Service bulletin

C
235
EXPORT
9

BRAKE PIPE POSITION

Arrows in sketch show pipes which may require attention.

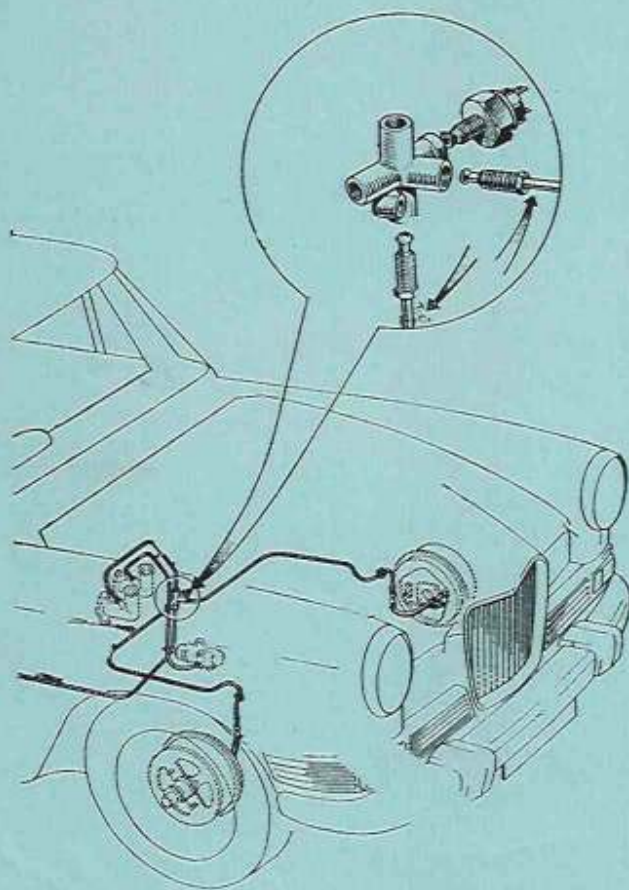
Instances have been reported of the brake pipe Part No. 1H215 positioned between the five way connection and L/H front brake hose lying too close to the rear of the engine. Also the brake pipe Part No. 1H5717 laying too close to the starter motor and gearbox mounting plate.

Vehicles in Service should be examined immediately and if the clearance is not sufficient to stop chafing, the pipes should be repositioned by a slight pressure at suspect areas.
